**ALERT SERVICE BULLETIN**

REVISION NOTICE

**SUBJECT: REVISION "A" TO ALERT SERVICE BULLETIN 212-00-110: FIN SPAR  
CAP P/N 212-030-125-001, P/N 212-030-447-001/101, INSPECTION OF**

Revision "A" to this bulletin increases the initial compliance period and clarifies it with the use of a table. The description is also more detailed to help operators differentiate between the different possible configurations.

FIGURE 1. (SHEET 1) - PART I

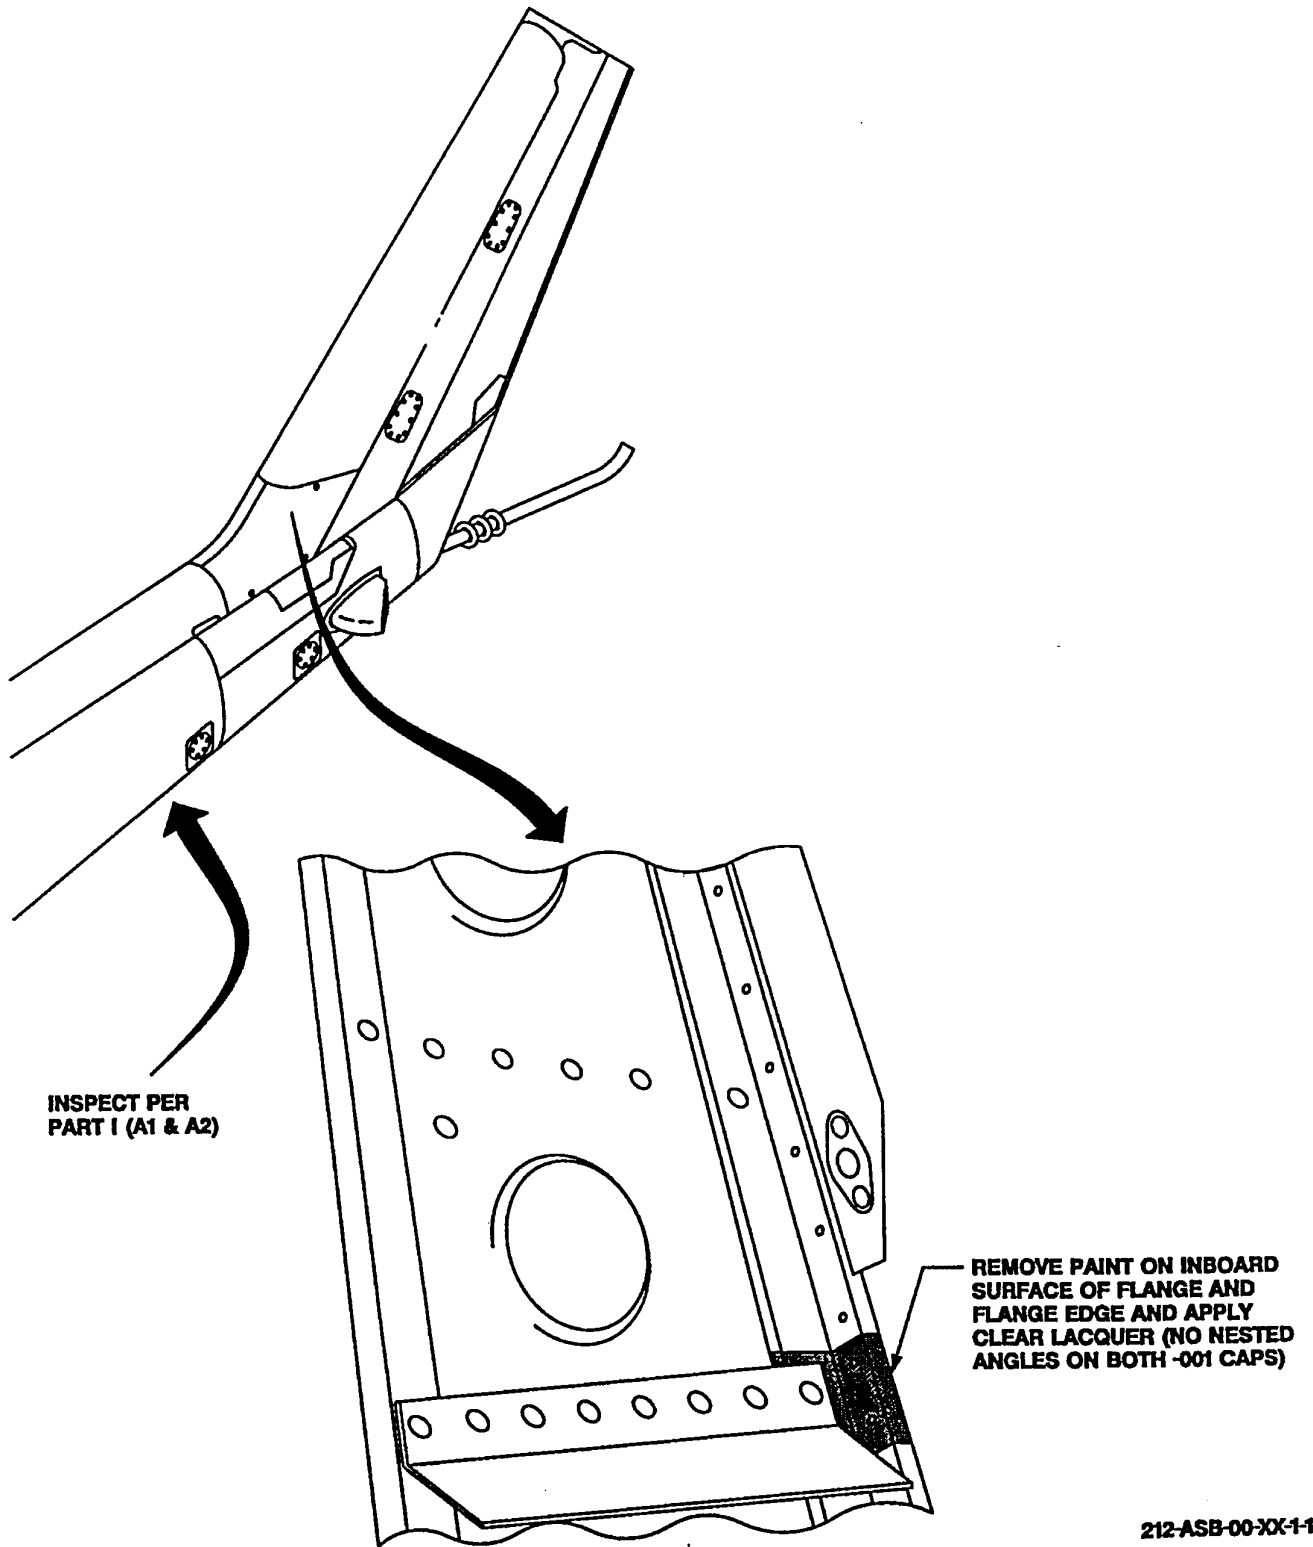
2. Do not use chemical paint strippers. Mask off area to be stripped and cleaned. Using Scotch-Brite TY-A (very fine)(C-407) and MEK, remove the paint and primer locally 0.38 inch maximum from around the two lower rivets on the inboard surface of the forward facing cap flange. See Figure 1.

4. Using bright light, a small mirror and a 10x magnifying glass, inspect the exposed areas of the spar assembly adjacent to the tailboom top skin looking from both the top and the bottom. Pay attention to the inboard surface of the spar cap between fin station 66.31 and 75.00, particularly in the area noted in Item 2. Access to fin station ~72.00 to 75.00 is difficult. This area should be inspected through the tailboom lower inspection door with a bright light and a mirror. Any questionable defect should be inspected more carefully with a boroscope. Refer to Figure 1.

Inspect by lightly tapping on the surface of the part. The number of taps per minute shall be such as to produce a continuous sound so that any differences in sound tone can be readily detected. The rate of tapping will vary, depending on the material and construction of the assembly. The force used in striking the surface will be to a degree that will not damage surfaces or finishes. Use tapping hammer P/N T75449-2 or equivalent to fit easily between rivets. Refer to Figure 1.

1. Remove lower aft inspection door, intermediate gearbox cover and tail rotor drive shaft cover.
2. Locate left fin spar edge and the doubler area. Refer to Figure 1 (Sheet 1).

FIGURE 1. (SHEET 2) - PART II

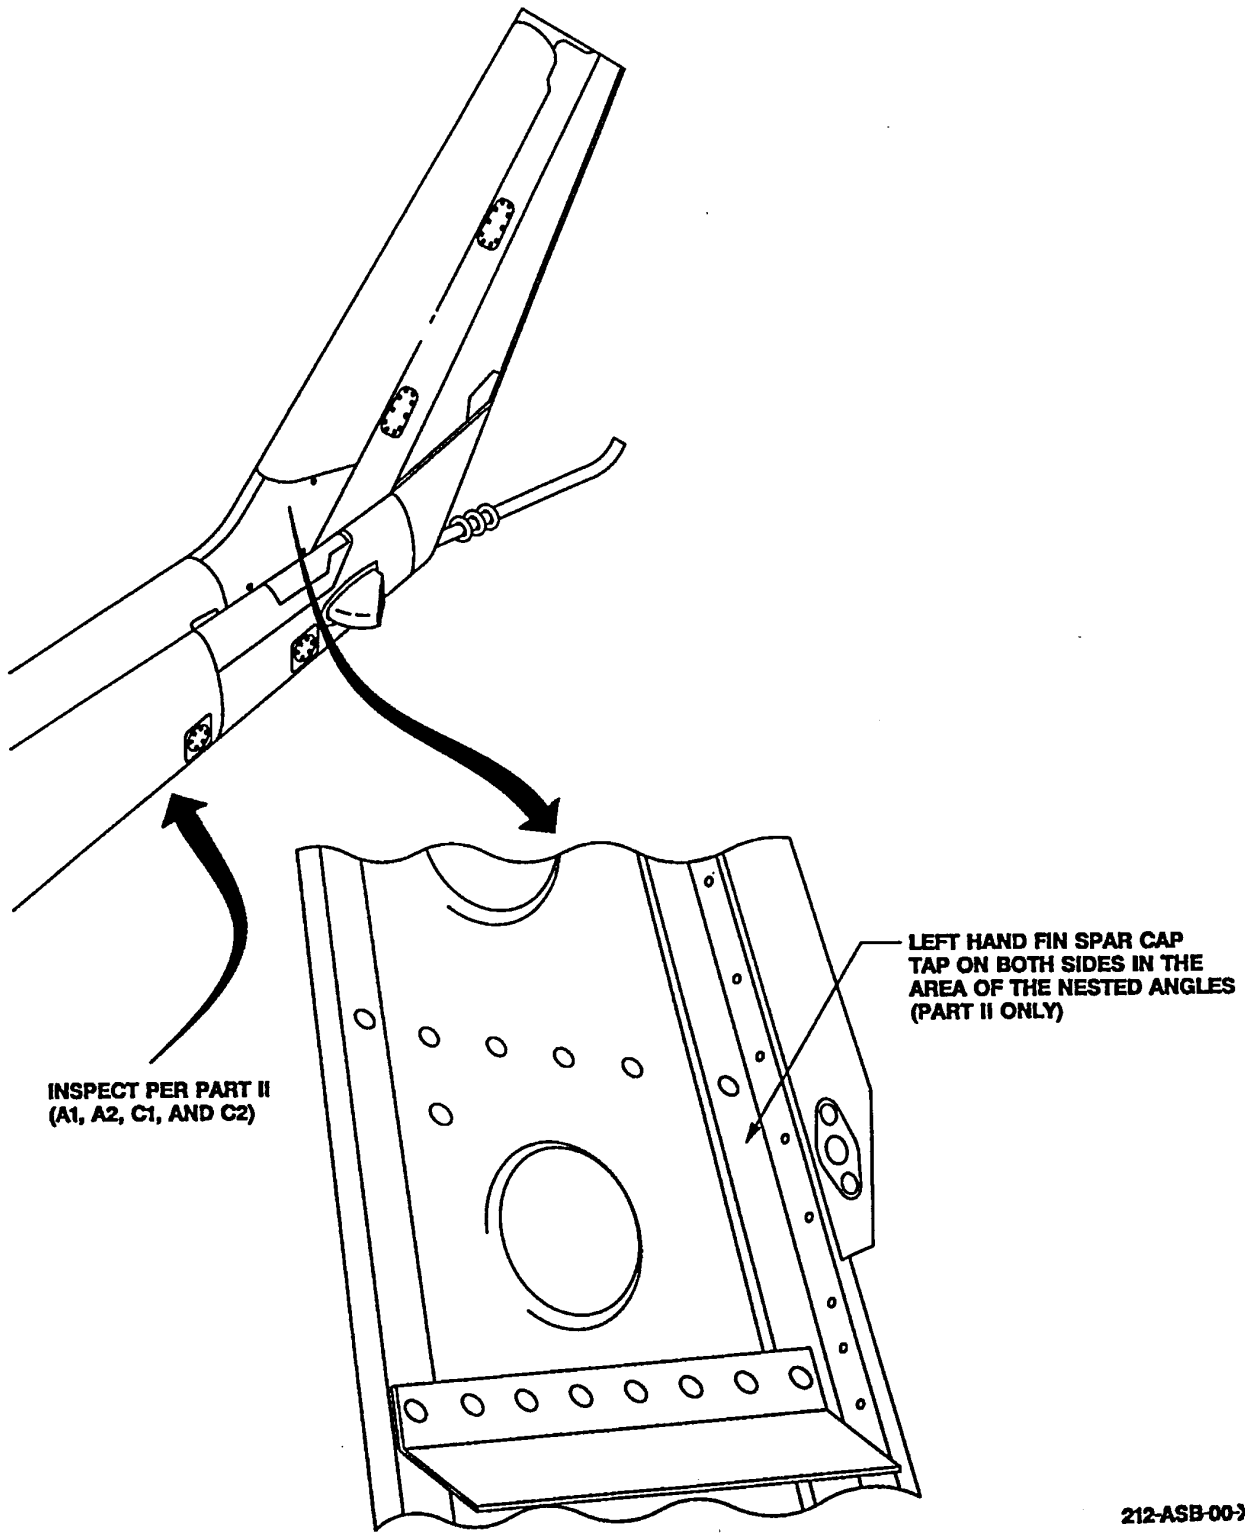
5. Using bright light, a small mirror and a 10x magnifying glass, inspect the exposed areas of the spar assembly adjacent to the tailboom top skin looking from both the top and the bottom. Pay attention to the inboard surface of the spar cap between fin station 66.31 and 75.00, particularly in the area noted in Item 2. Access to fin station ~72.00 to 75.00 is difficult. This area should be inspected through the tailboom lower inspection door with a bright light and a

mirror. Any questionable defect should be inspected more carefully with a boroscope. See Figures 1, 2 and 3.

3. Using bright light, a small mirror and a 10x magnifying glass, inspect the exposed areas of the spar assembly adjacent to the tailboom top skin looking from both the top and the bottom. All visible area of the spar cap is to be inspected, without removing the inspection doubler installed per Part II (C1) of this bulletin. Pay attention to the inboard surface of the spar cap between fin station 66.31 and 75.00, particularly in the area noted in Item 2. Access to fin station ~72.00 to 75.00 is difficult. This area should be inspected through the tailboom lower inspection door with a bright light and a mirror. Any questionable defect should be inspected more carefully with a boroscope. See Figures 1, 2 and 3.

FIGURE 2. (SHEET 1 OF 2) - PART II INSPECTION CONFIGURATION FOR 212-030-447-101

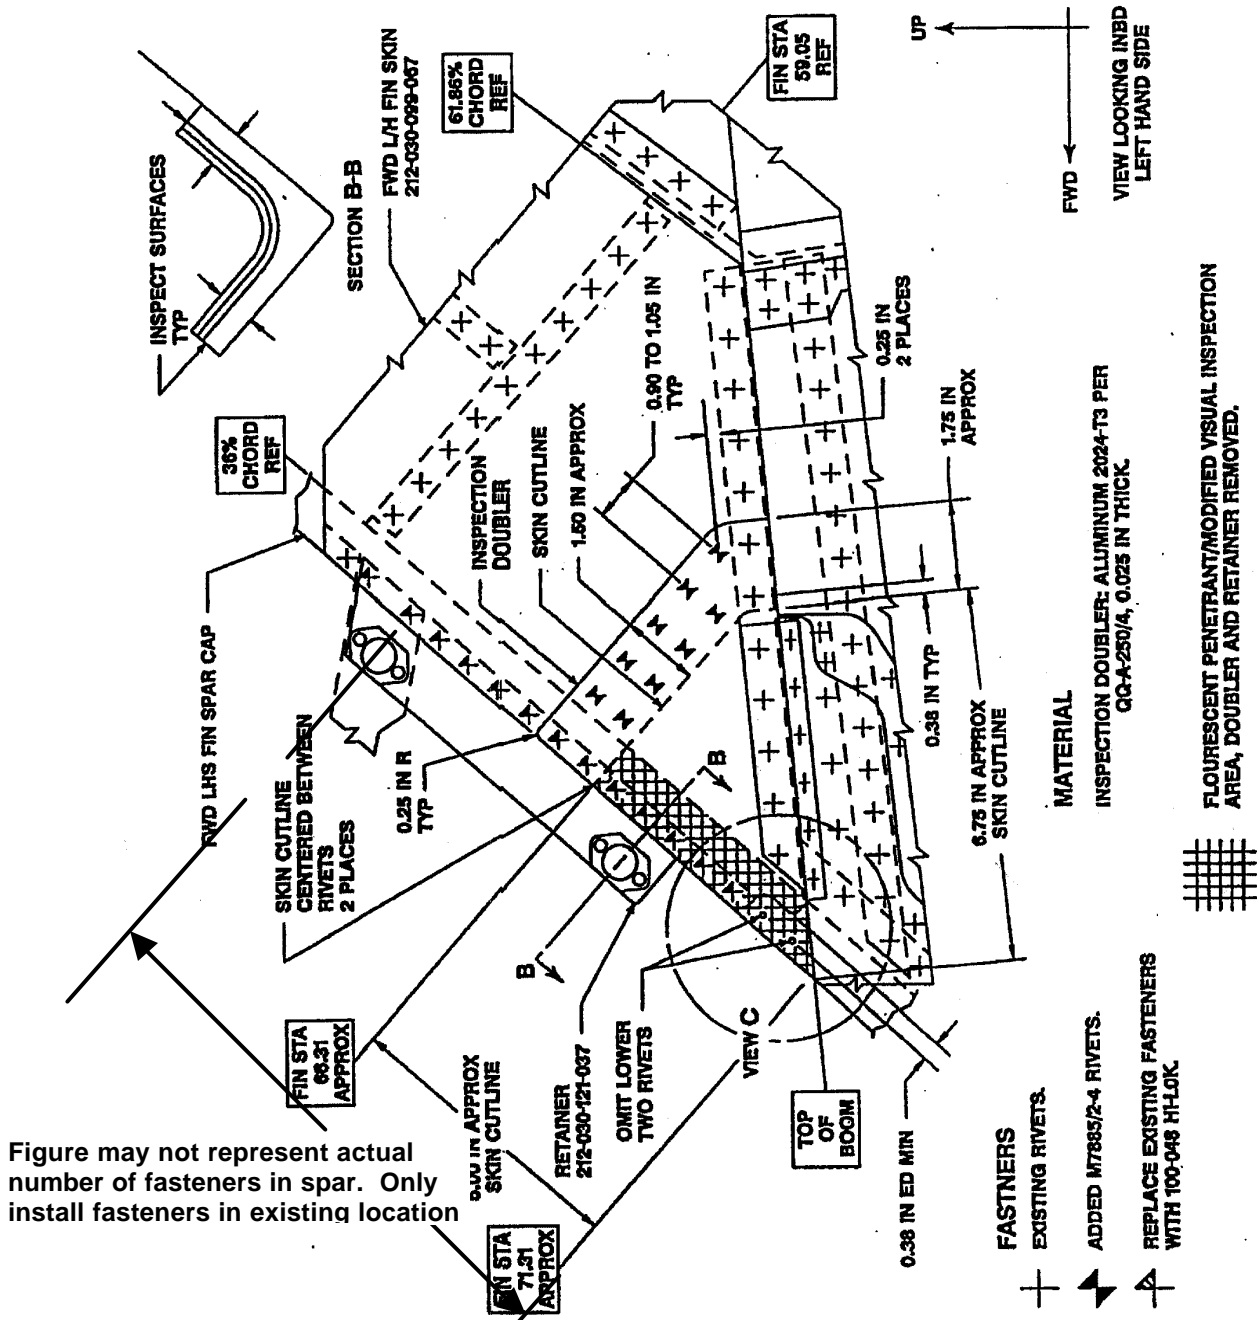
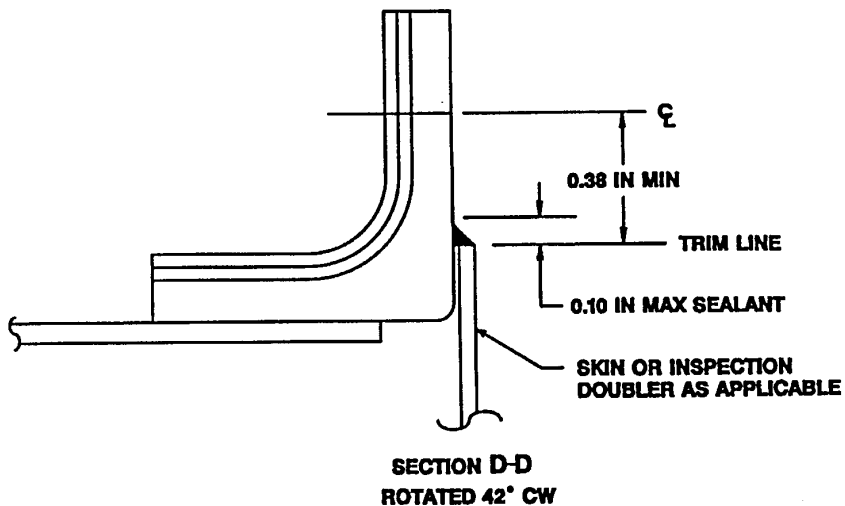
3. Do not use chemical paint strippers. Mask off area to be stripped and cleaned. Using Scotch-Brite TY-A (very fine) (C-407) and MEK, remove paint and primer locally 0.38 inch maximum from around the two lower rivet holes on the cap flange outboard surface (see Figure 2 or 3). Deburr holes in the spar where rivets were removed.

6. Any discrepancies (cracks, corrosion, disbonds or other damage) require approval by Bell Helicopter Product Support Engineering before further flight. See Part I (A1), Item 5 for address.
7. After inspection, apply MIL-PRF-81352 clear lacquer inside the two lower rivet holes and on the surface where paint and primer were removed. Spray, brush or wipe on a protective coat of MIL-C-16173, Grade 2 over the clear lacquer. To facilitate subsequent inspections, **do not replace the two lower rivets**. See Figure 2 or 3.

8. Fasten the FWD L/H Fin Skin and the P/N 212-030-121-037 or P/N 212-030-121-033 Retainer back to the spar assembly using Hi-Loks and blind rivets as shown in Figure 2 or Figure 3. Reinstall Clip and Radius Block (if existing) removed in item 2.
9. Refinish reworked area as per instructions found in Standard Repair Manual except in area where protective coat of MIL-C-16173, Grade 2 was used.
10. Install the inspection door, intermediate gearbox cover and tail rotor driveshaft cover.
11. Make an entry in helicopter historical records indicating compliance with this bulletin.

2. Remove the P/N 212-030-099-091 Clip and P/N 212-030-099-095 Radius Block, if existing. Remove the P/N 212-030-121-037 or P/N 212-030-121-033 Retainer and sufficient rivets from the bottom row of the FWD L/H Fin Skin to allow trimming of the FWD L/H Fin Skin along the "skin cutline", approximately Fin Station 66.31. See Figure 2 or 3.

3. Do not use chemical paint strippers. Mask off area to be stripped and cleaned. Using Scotch-Brite, TY-A (very fine)(C407) and MEK, remove paint and primer in the crosshatched area shown in Figure 2 or 3 (Sheet 1).

5. If facility and/or personnel are not approved to perform a fluorescent penetrant inspection, proceed to Item 7.
6. Carry out the fluorescent penetrant inspection of the area shown in Figure 2 or 3 using the procedure stated in the Standard Practices Manual, BHT-ALL-SPM, Chapter 6.2. Proceed to Item 8.

**FIGURE 2. (SHEET 2 OF 2) - PART II INSPECTION CONFIGURATION FOR 212-030-447-101**

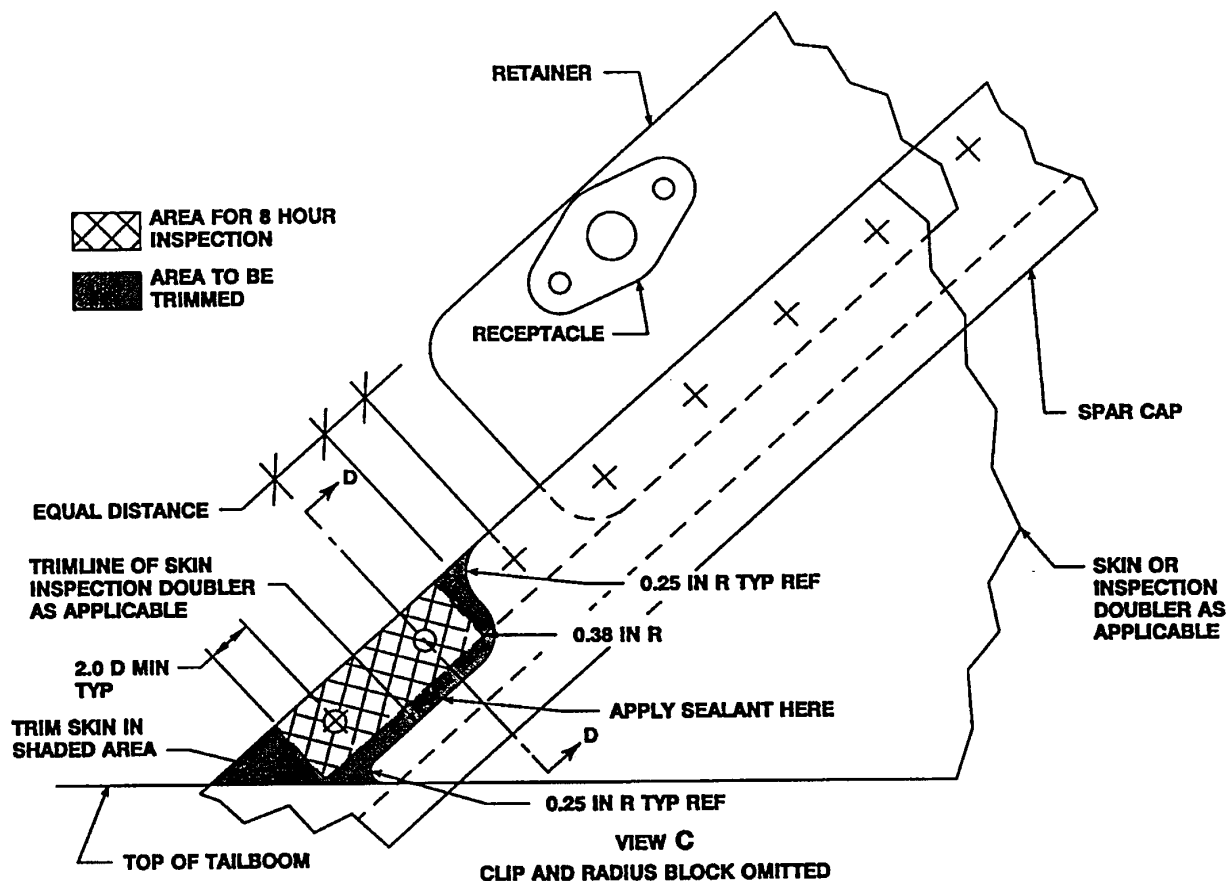
11. After inspection, mask off area designated for 8-hour inspections, reference Figure 2 (Sheet 2) or Figure 3 (Sheet 2) and apply unreduced zinc chromate primer, TT-P-1757, to the remaining bare surface. When dry, remove masking and apply MIL-PRF-81352 clear lacquer to the crosshatched area shown in
